ADDENDUM NO. 1A

Good Shepherd Catholic Church Community Center

July 27, 2026

GRC Project 21275

P1.10

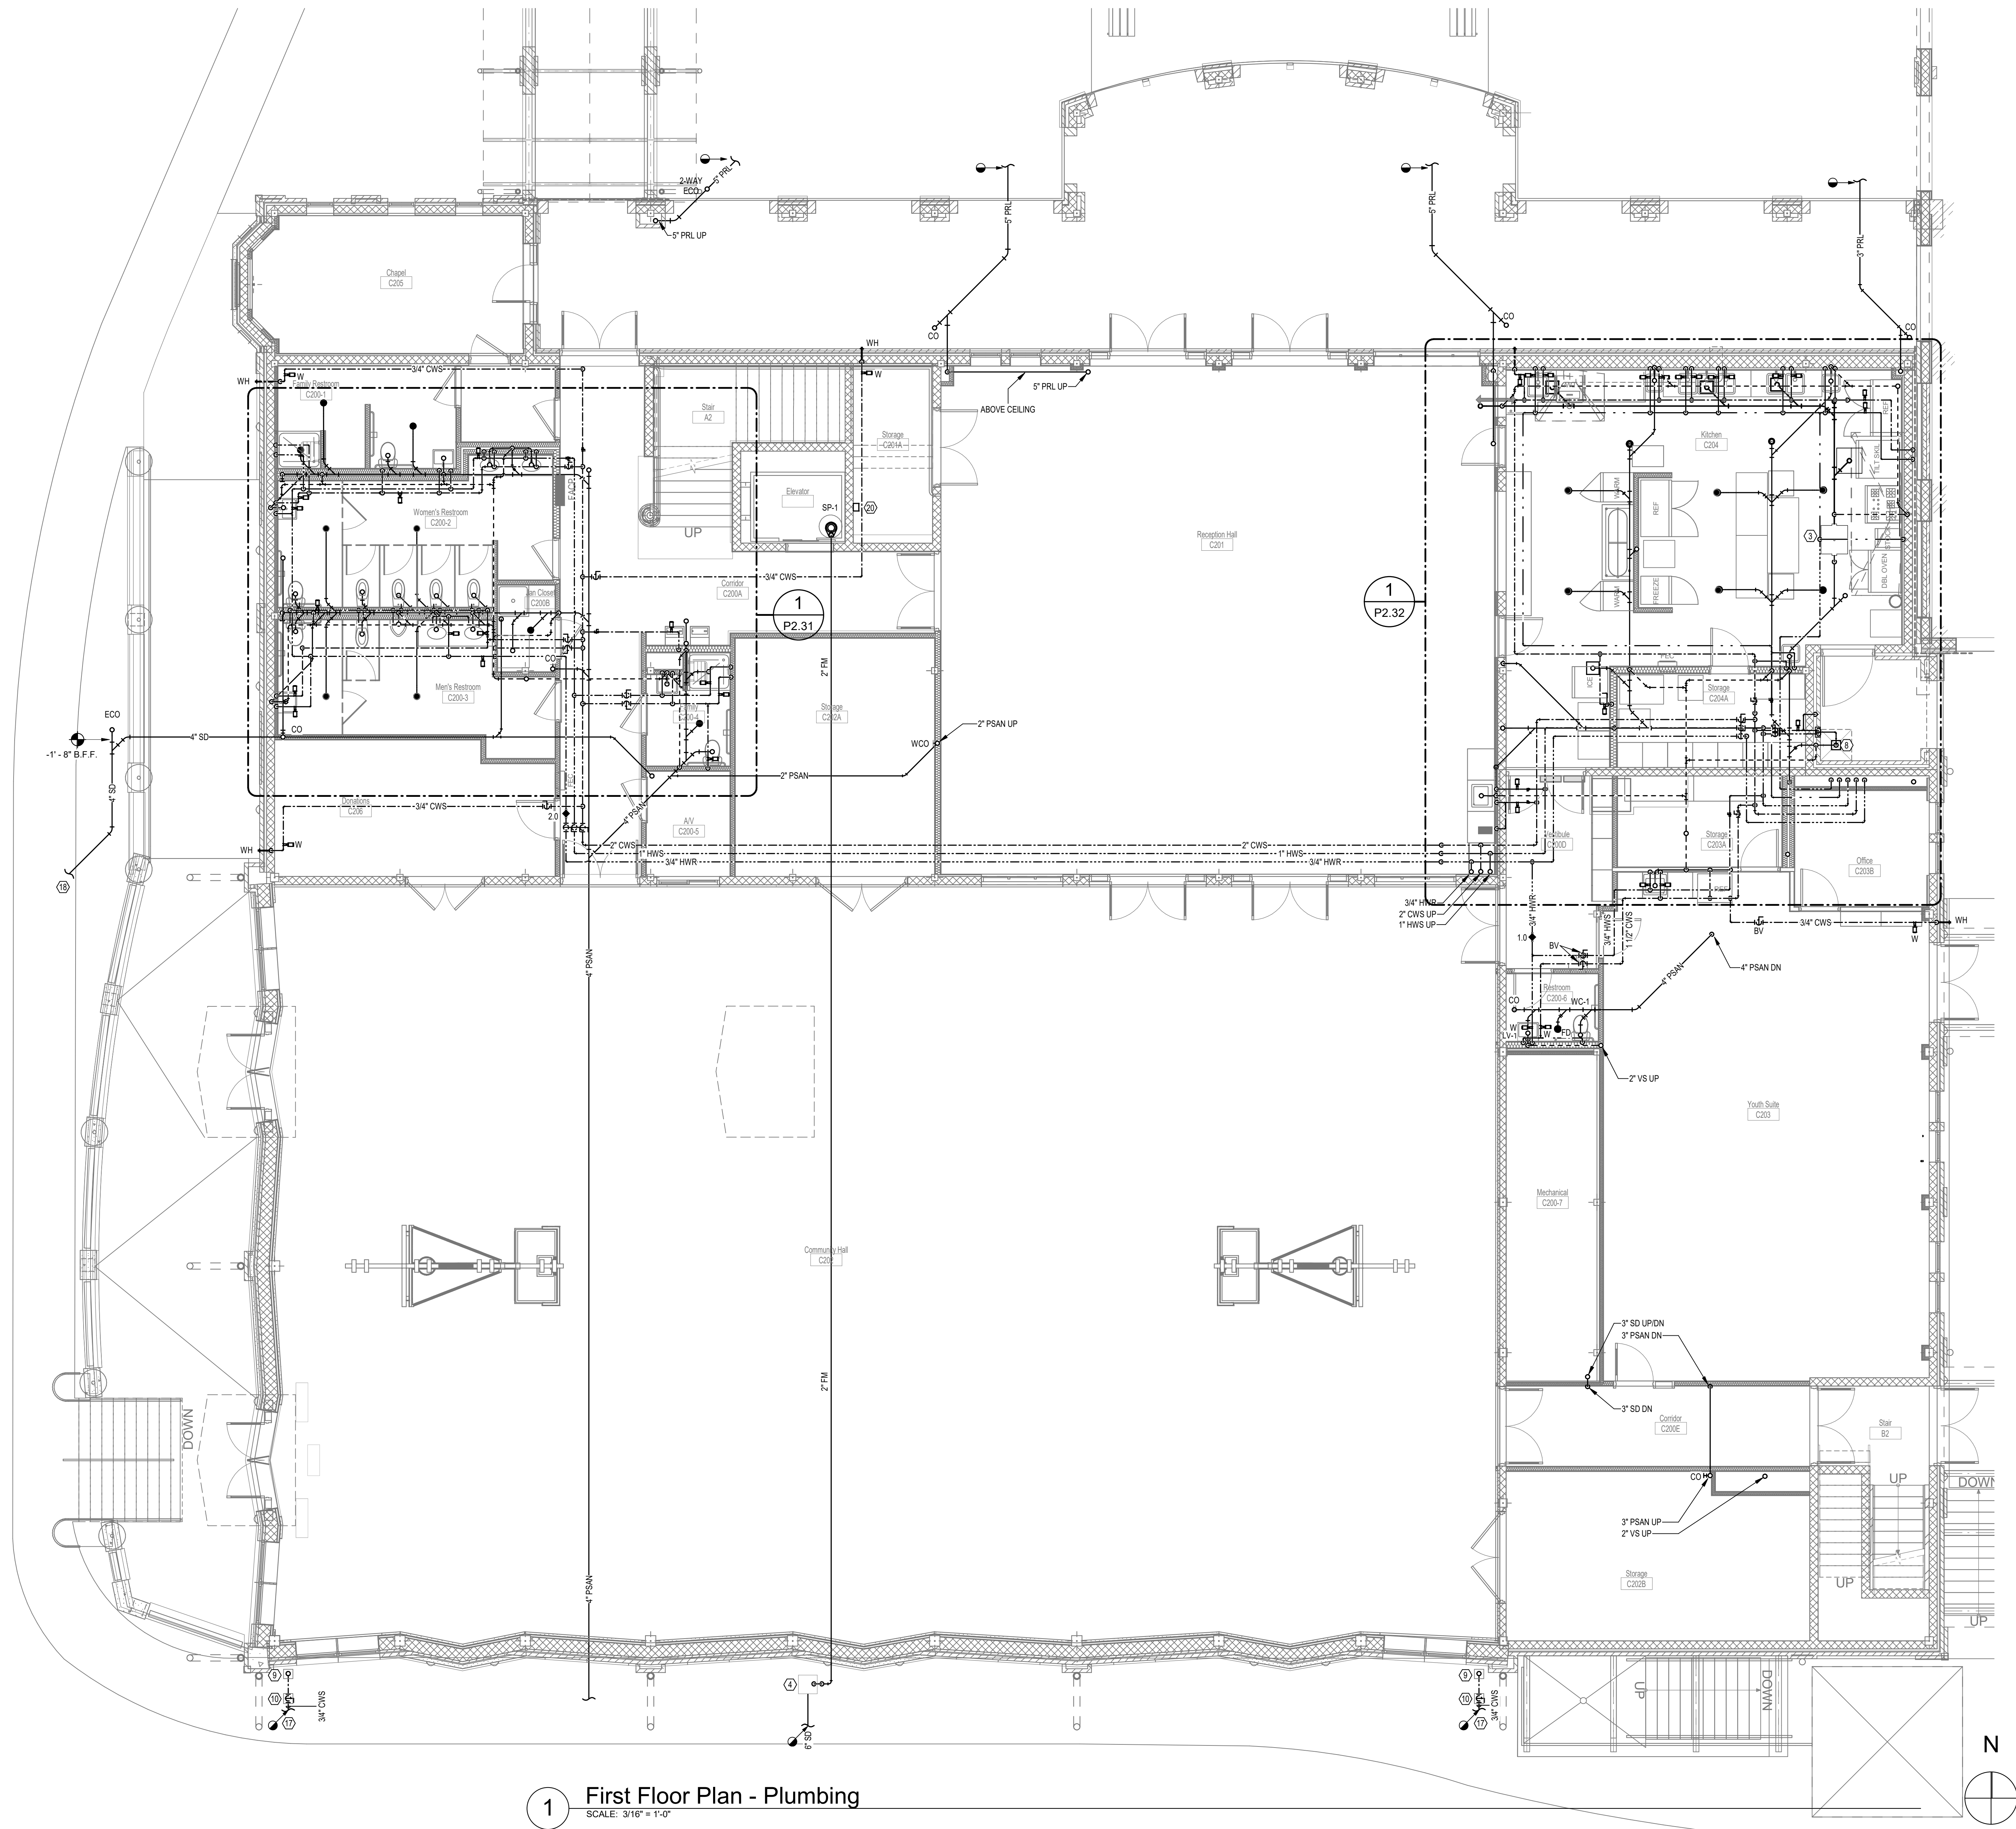
- Item P1.1.2 **Revise** overall plumbing engineering design layout of the sanitary waste piping. Storm drain pipe size alterations. Location of supply piping risers has shifted, and pipe sequence order has changed.
Remove everything related to the scope of fuel natural gas. Fuel Gas lines now has its own set of plans.
Revise detail reference on Plumbing Plan Keynote 6.

SHEET
P1.11

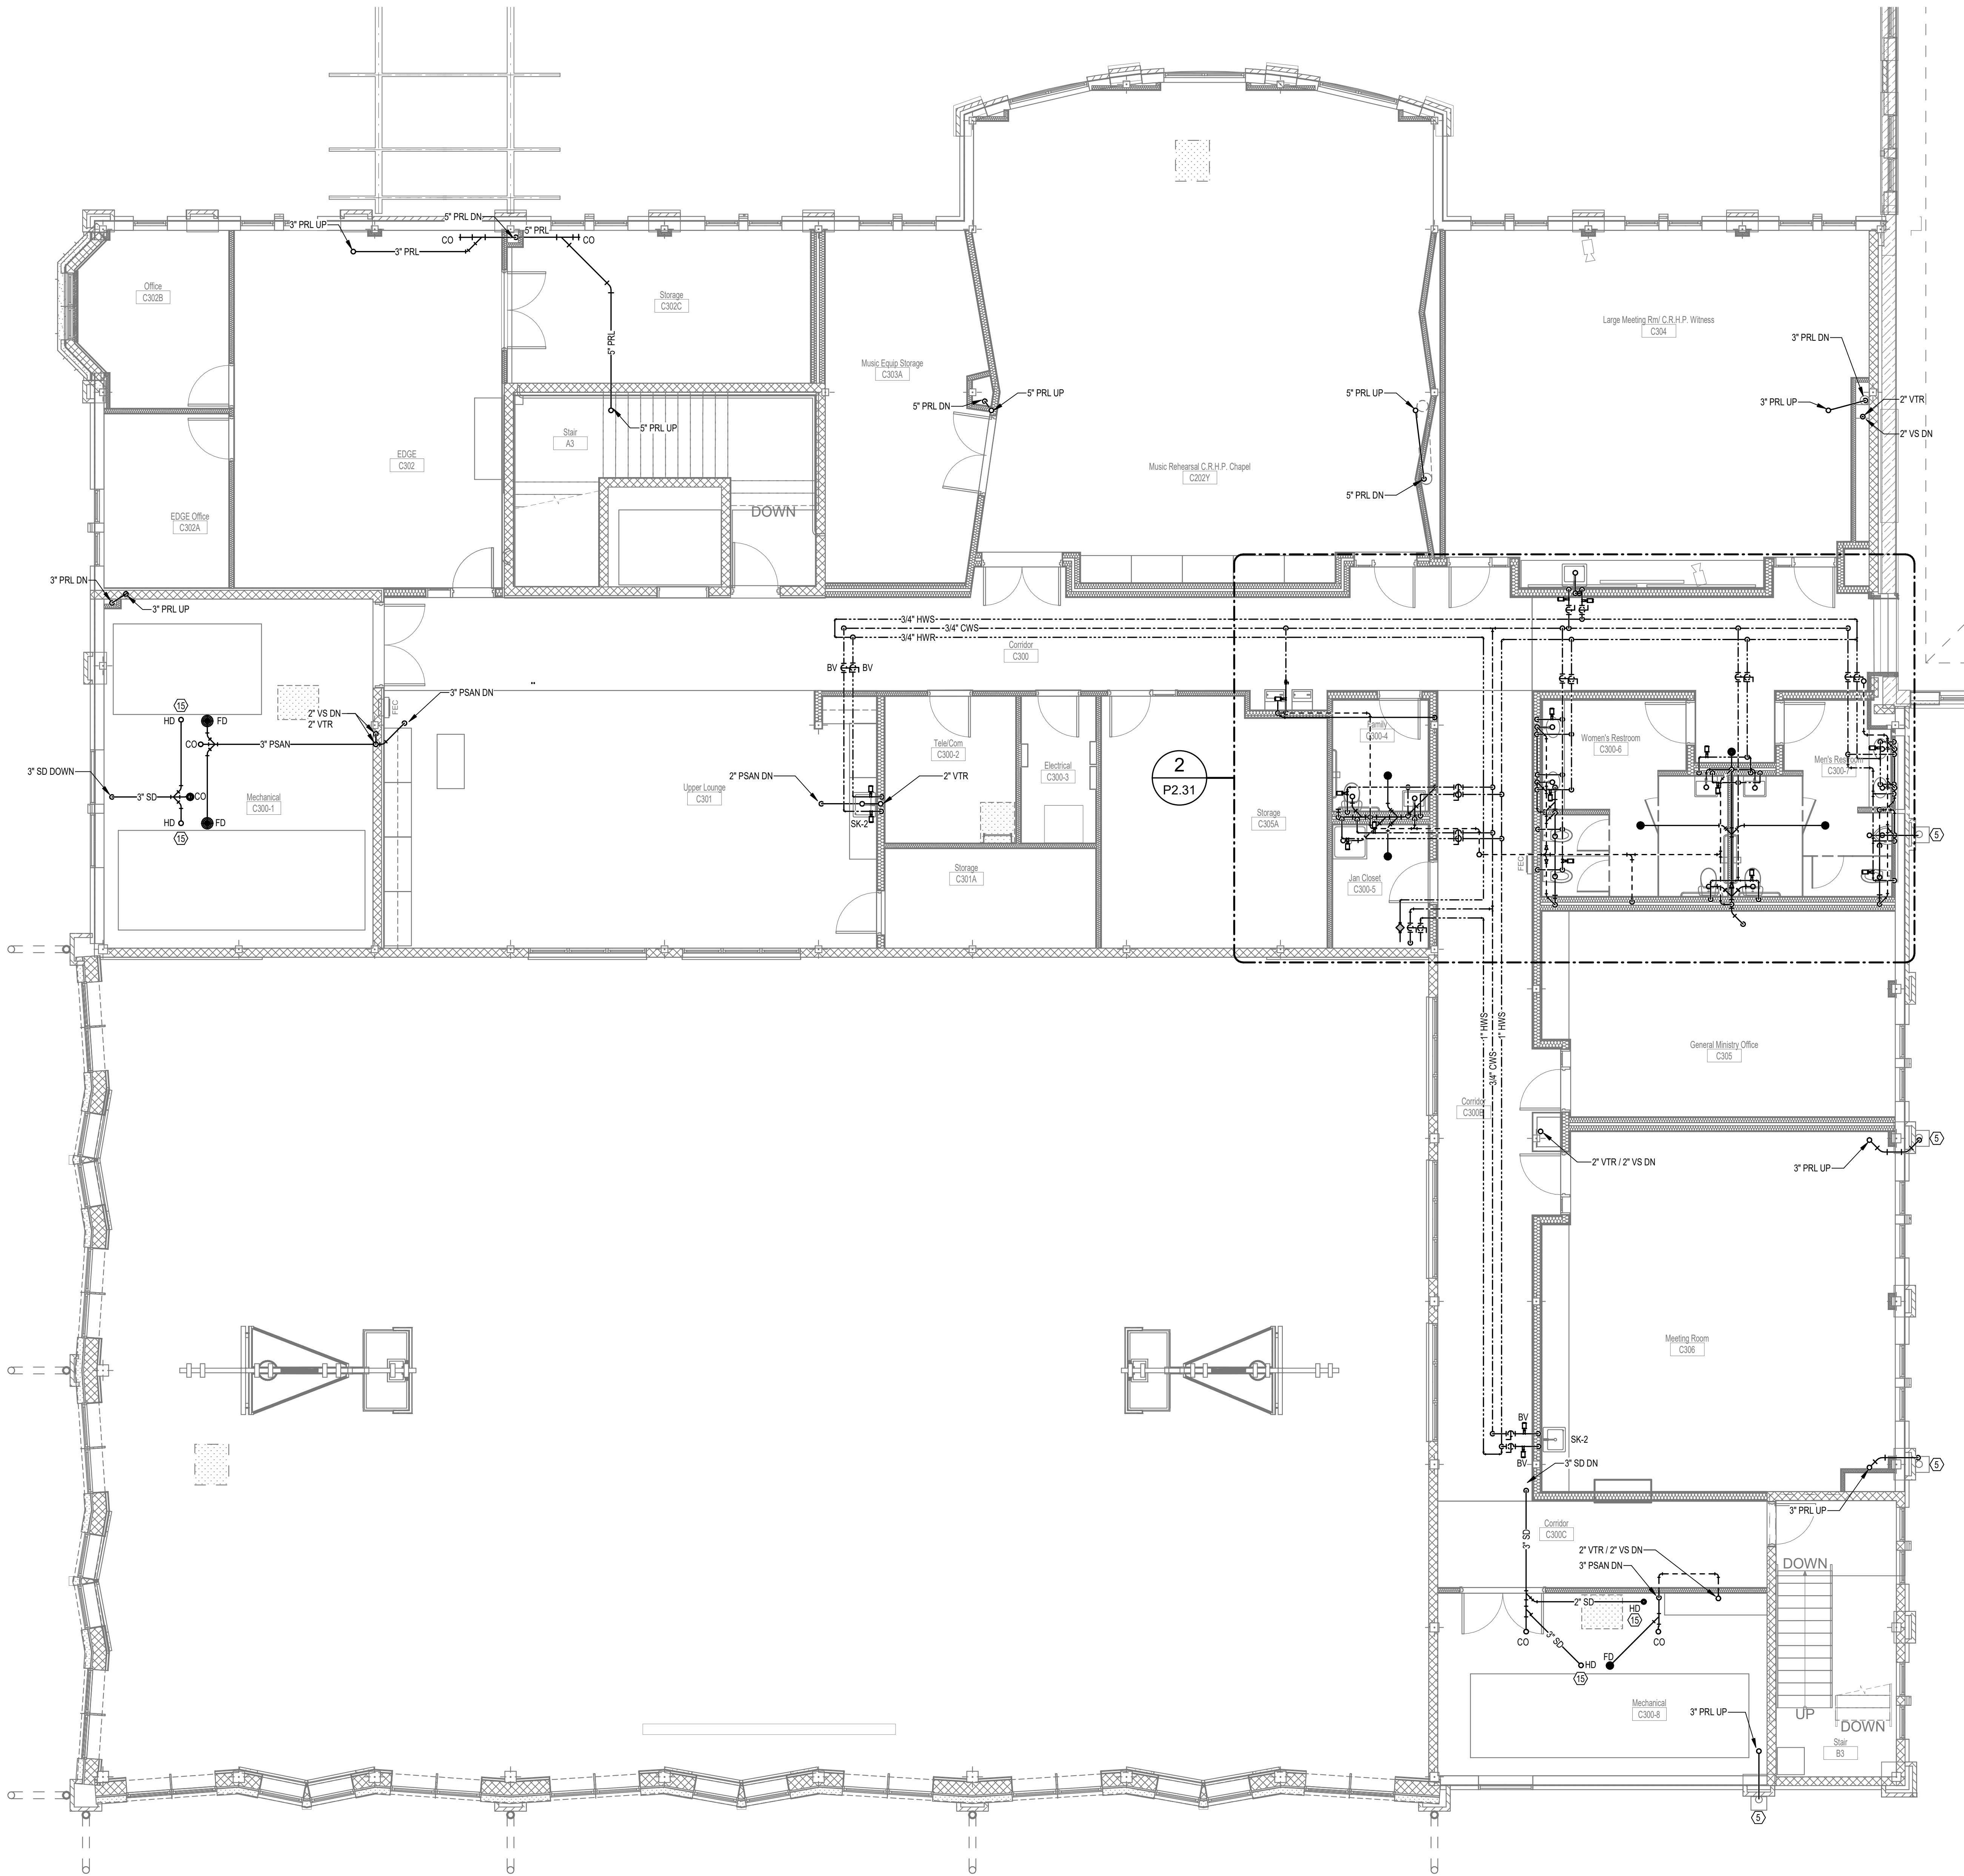
- Item P1.1.3 **Revise** overall plumbing engineering design layout of the following systems: Sanitary, venting, storm drain and all Domestic supply and return systems. See enlarged plans for more information
Revise layout of Primary rain leader piping, located at the north side of the building.
Add wall hydrants and corresponding piping.
Revise Plumbing Plan Keynote 8.
Add Plumbing Plan Keynotes 16,17,18, 19 and 20.
Add Storm drain riser near Mechanical C200-7.
Add Oil Spotter for elevator sump pump in storage C201A.
Remove everything related to the scope of natural gas. Natural gas lines now has its own set of plans.

SHEET
P1.12

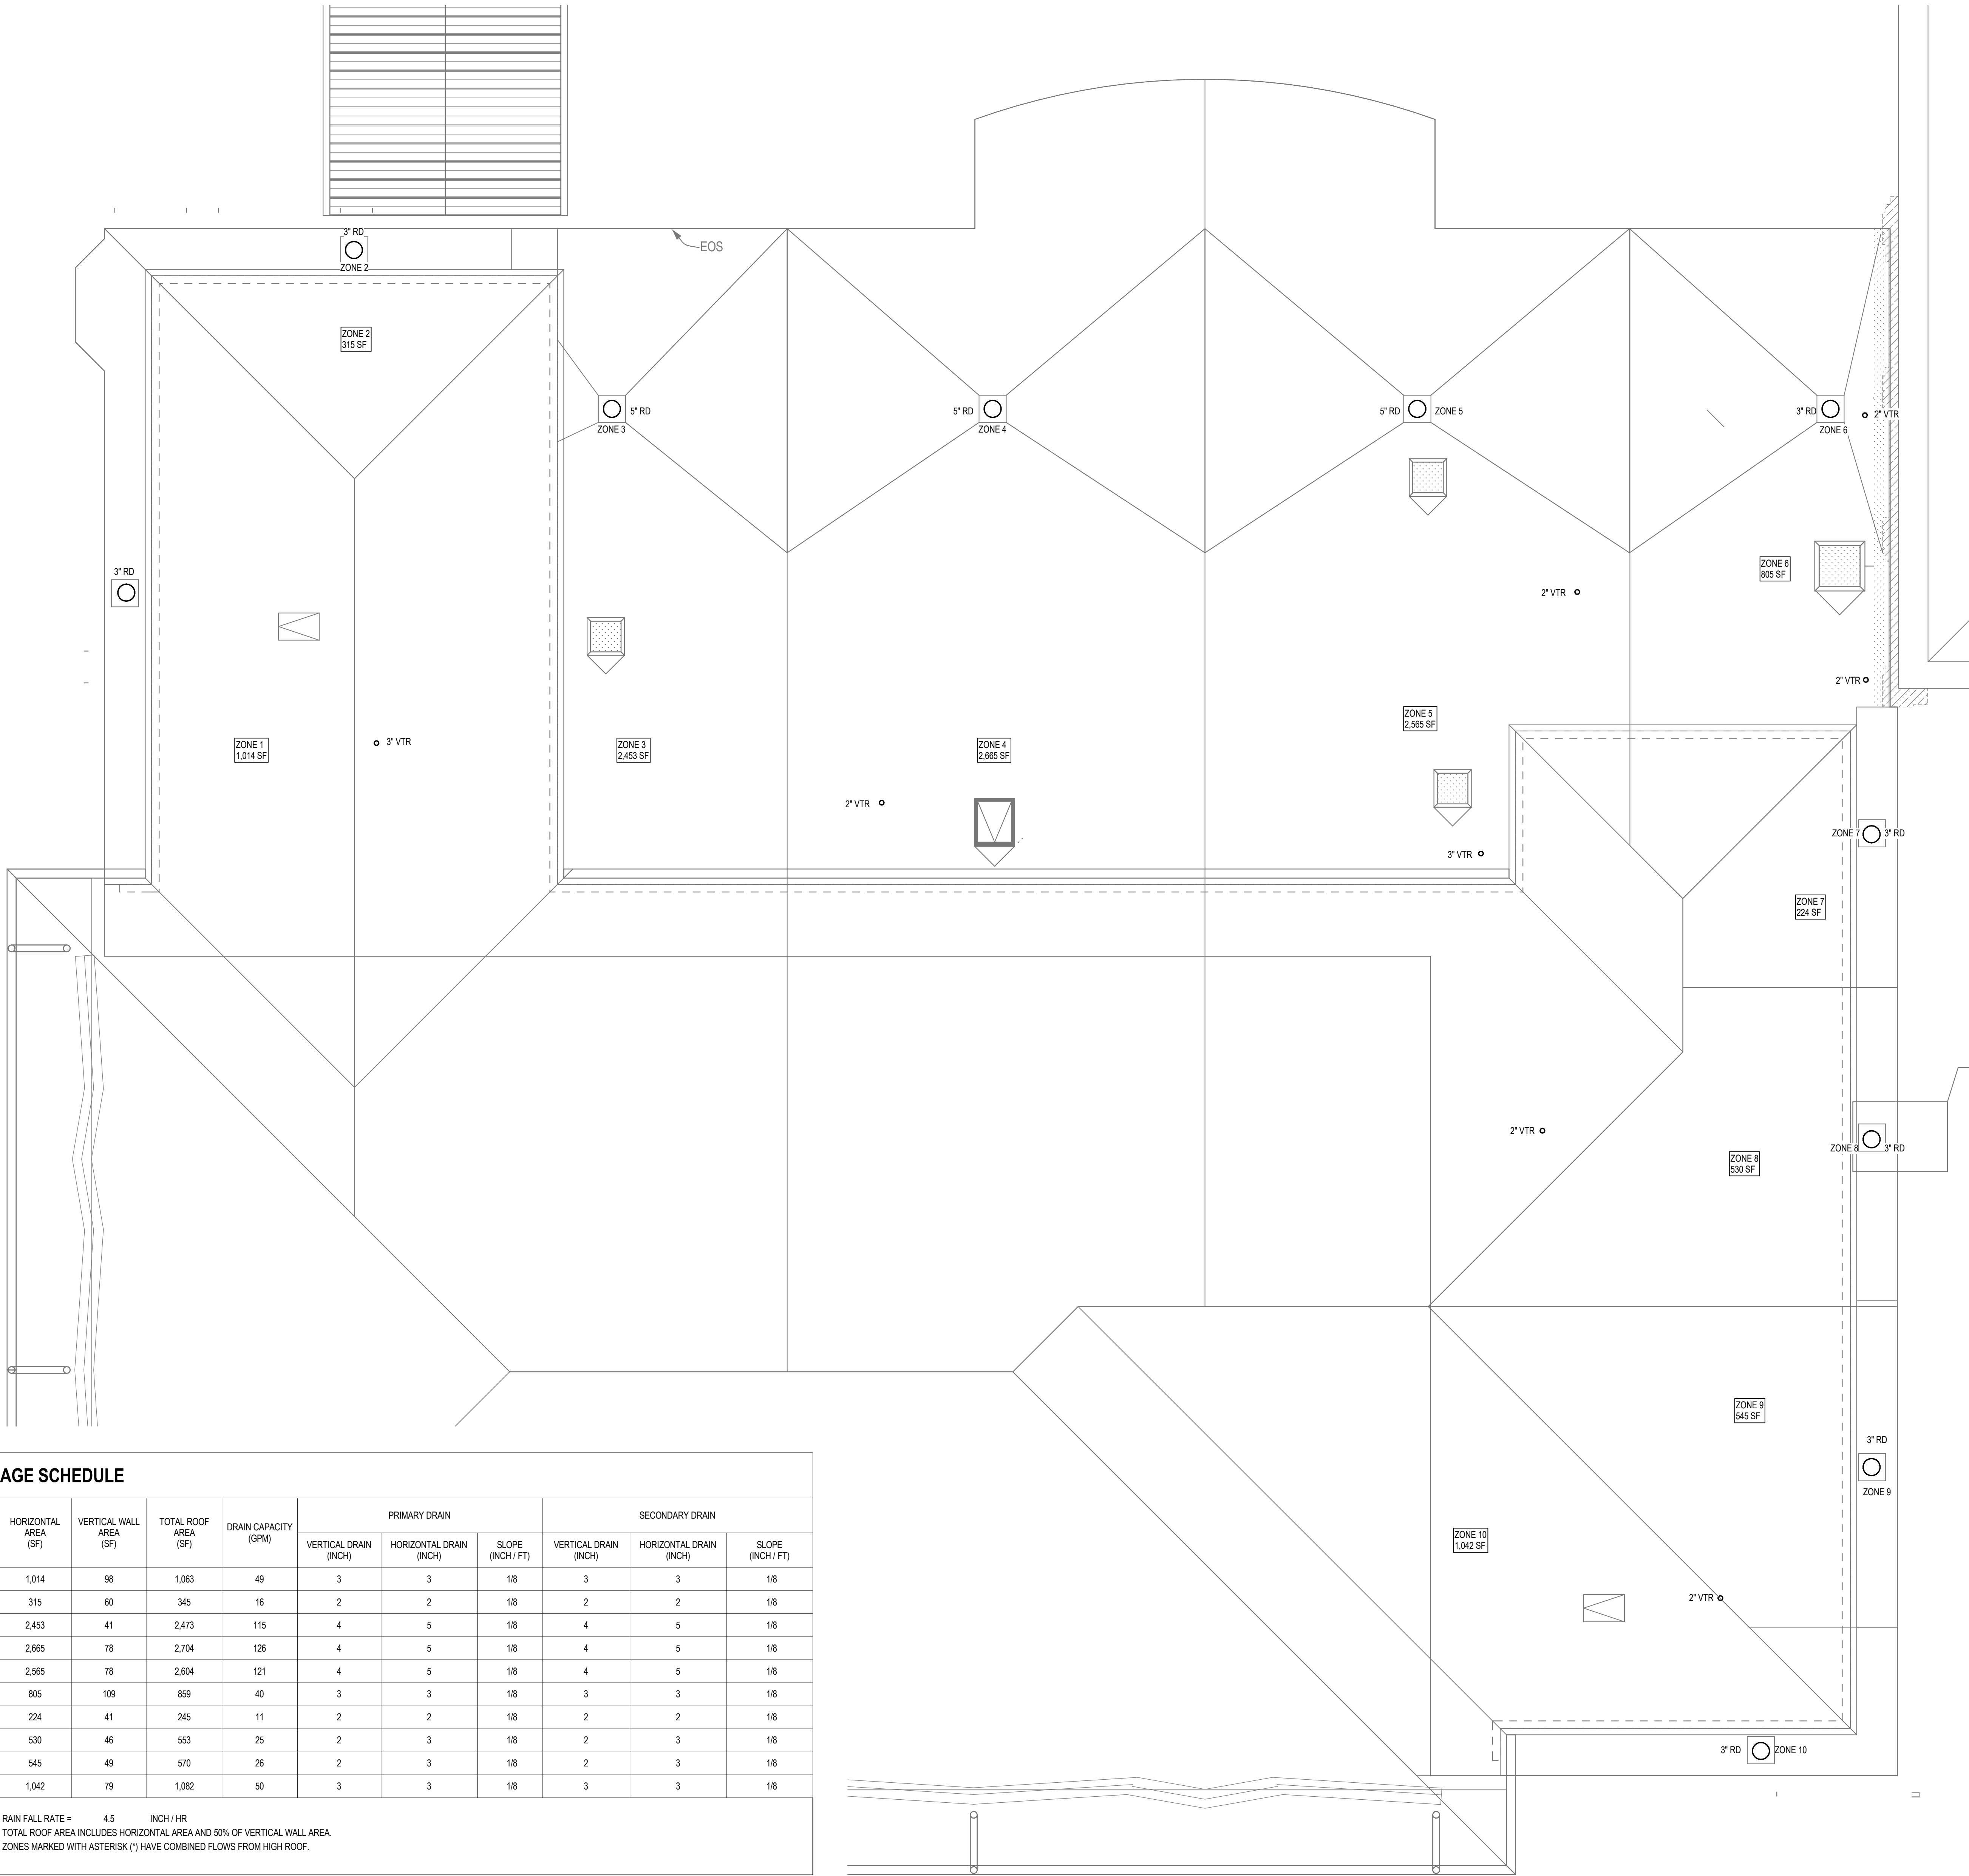
- Item P1.1.4 **Revise** overall plumbing engineering design layout of the sanitary and venting layout. Slight alterations to the Domestic supply and return layout. See Restroom enlarged plans for more information.
Revise sanitary and storm drain system layout in Mechanical Rooms C300-1 and C300-8. Concrete equipment pads now showing on plan.
Revise primary rain leader in Mechanical C300-1.
Add Plumbing Plan Keynote 19.
